Subject: The Wildfire Safety Division Issuance of Revision Notice for Pacific Gas and Electric Company's 2021 Wildfire Mitigation Plan Update and Notice of Extension of WSD Determination Per Public Utilities Code 8389.3(a)

Wildfire Safety Division's Revision Notice for Pacific Gas & Electric Company's 2021 Wildfire Mitigation Plan Update

Figure 1: PG&E’s Reported VM Territory Cycle Expenditure

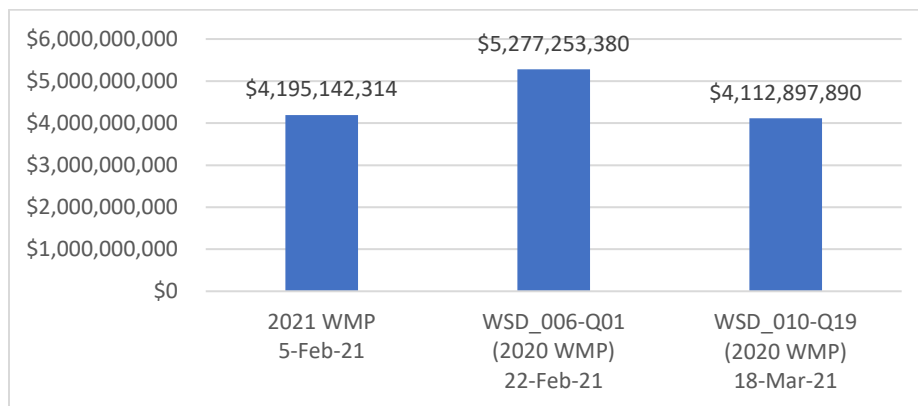
\$5,277,253,380,⁴⁷ and the VM HFTD Cycle expenditure was \$2,593,528,635.⁴⁸ The VM HFTD Cycle expenditure matches expenditure reported in PG&E’s First Quarterly report. However, VM Territory Cycle expenditure is reduced by \$1,082,111,066 relative to the 2021 WMP (see Figure 1).

On March 18, 2021, PG&E submitted “WildfireMitigationPlans_DR_WSD_010-Q19Atch01.xlsx” in response to DR WSD_010-Q19. In this response, PG&E reported the 2020 WMP VM Territory Cycle expenditure (as initially asked in WSD_006-Q01) as \$4,112,897,890.⁴⁹ This value is \$1,164,355,491 less than previously reported in PG&E’s response to WSD_006-Q01; *the WSD expects these figures to be the same, or very similar*. Variation in the VM Territory Cycle expenditure is illustrated by Figure 1.

The new values submitted on March 18, 2021 as part of its response to DR WSD_010-Q19 have not yet been justified by PG&E.

Critical Issue No.	Critical Issue Title	Required Remedies
PGE-05	Unresolved Discrepancies in Vegetation Management Expenditure Data and their Effect on the Entire WMP	<ol style="list-style-type: none"> 1. PG&E shall submit a revised Table 12 in the format of the attached Excel file named "PG&E Revision Table 12 Template.xlsx." This includes: <ol style="list-style-type: none"> a. Annual expenditure, split by capital expenditure and operating expenditure, for each WMP initiative in HFTD and in its total territory (HFTD + non-HFTD), as forecasted in 2020 and reported in 2021; b. Columns K-AB require 2020 WMP forecasted expenditure for the 2020-2022 WMP cycle; c. Columns AC-AT require 2021 WMP Update forecasted expenditure for the 2020-2022 WMP cycle (actual expenditure for 2020 + forecasted expenditure for 2021 and 2022). 2. PG&E shall explain in full and complete detail why the expenditure information in WSD-006-Q01 is so drastically different from previous submissions. 3. PG&E shall explain in full and complete detail what quality controls it has in place to ensure accurate and consistent reporting of expenditure. 4. PG&E shall explain in full and complete detail how it will ensure accuracy and consistency of the information contained within its future WMP submissions (particularly in relation to expenditure) going forward.

Figure 2: PG&E's 2020 Reported WMP VM HFTD Cycle Expenditure

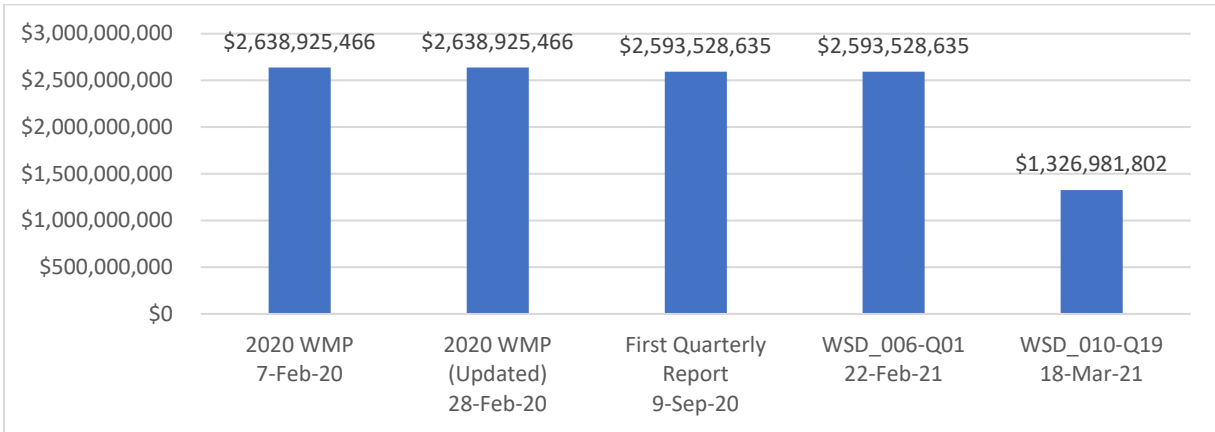
Similarly, in response to WSD_010-Q19, PG&E reported the 2020 WMP VM HFTD Cycle expenditure as \$1,326,981,802.⁵⁰ This value is \$1,266,546,833 less than previously reported in PG&E’s response to WSD_006-Q01 and less than every other prior submission mentioned in this analysis: *these figures should be the same*. Variation in the 2020 WMP VM HFTD Cycle expenditure is illustrated by Figure 2.

PG&E previously explained the difference in HFTD forecasted expenditure (Figure 2) between the 2020 WMP and the First Quarterly Report/ WSD_006-Q01 in its response to Condition Guidance-5 (Class B) from Resolution WSD-002. The response to Condition Guidance-5 and explanation of the “updated spend” can be found in PG&E’s First Quarterly Report.⁵¹ In the “Wildfire Safety Division Evaluation of Pacific Gas and Electric Company’s First Quarterly Report,” published January 8, 2021, the WSD found PG&E’s response to Condition Guidance-5 to be Sufficient.⁵²
